UNITED STATES PATENT AND TRADEMARK OFFICE

10/072,032

Office Action Summary

DETAILED ACTION

FIG. 1.

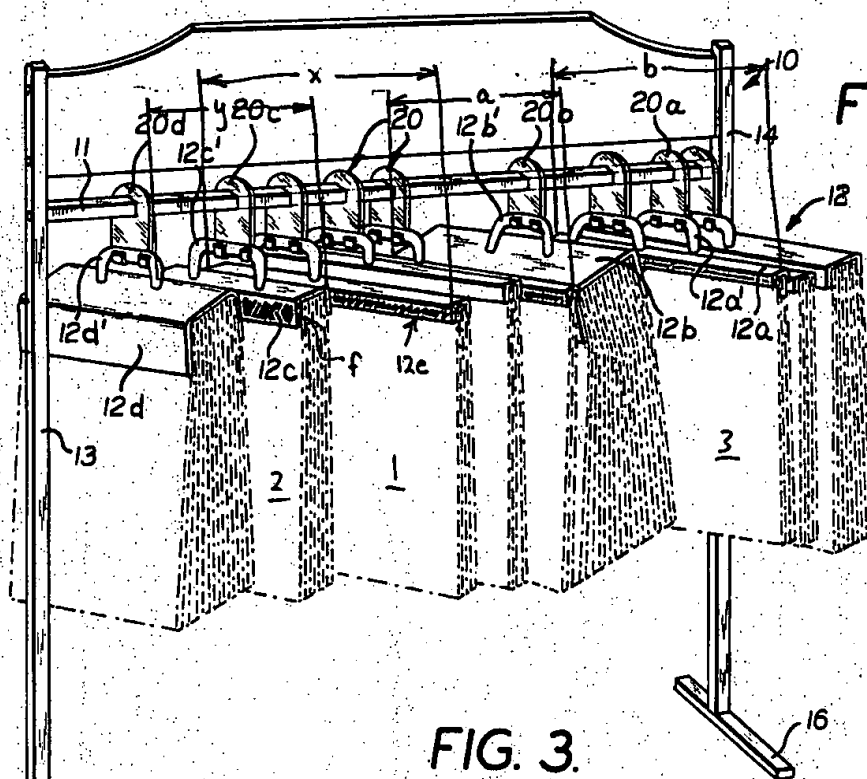
Howard '852 discloses a display device (see attached red-marked photocopy of Figure 1) comprising a rack (including elements 11 and 13-16) having at least one support member (at 11) having a body portion (13-16) extending therefrom; a first array of at least two display panels (12c and 12e) mounted (through elements 12c and 12e, respectively) to a first side, i.e., left side of Figure 1, of the rack whereby one of the display panels (12e) is an underlying panel having a first display surface (red - at 12e) with a sample of a first displayed floor covering material (1), i.e., carpet, mounted thereon and the first display surface (12e) having a first width (x) and a first height; another one of the display panels (12c) in the first array defining an overlying panel having a second width (y) and a second height and an inner edge (at 20c) mounted to the rack and a free edge (f) distal the inner edge whereby the second width (y) is sufficiently less than the first width (x) such that at least a portion of the floor covering material (1) is visible beyond the

free edge (f) of the overlying panel (12c) with the overlying panel (12c) overlying the underlying panel (12e); the display device further comprising a second array of display panels (red, below elements 12a and 12b) mounted to a second side, i.e., the right side of Figure 1, of the rack; one of the panels (on 12a) in the second array defining a second underlying panel having a display surface with a sample of a second displayed floor covering material (3) mounted thereon whereby the second display surface (on 12a) has a third width (b) and a third height; another one (on 12b) on the panels of the second array defining a second overlying panel having a fourth width (a) and a fourth height and an inner edge (at 20b) mounted to the rack; the fourth width (a) being sufficiently less than the third width (b) such that at least a portion of the second material (3) is visible with the second panel (on 12b) overlying the second panel (on 12a).

The claims differ from Howard '852 in requiring the panels tot be *pivotally* mounted to the rack.

Accordingly, it would have been obvious to one of ordinary skill in the art at the time the invention was made to have provided the panels of Howard '852 on a rack, such as taught by Capel '809, so that the panels of Howard '852 would be *pivotally* mounted to the rack, i.e., the panels (12a, 12b, 12c, and 12e) would be mounted to element 94 of Capel '809 by element 94 of Capel '809 grasping elements 12a', 12b', etc. of Howard '852, for ease in use of the device by consumers since the panels can be pivoted thereby allowing access to certain panels.
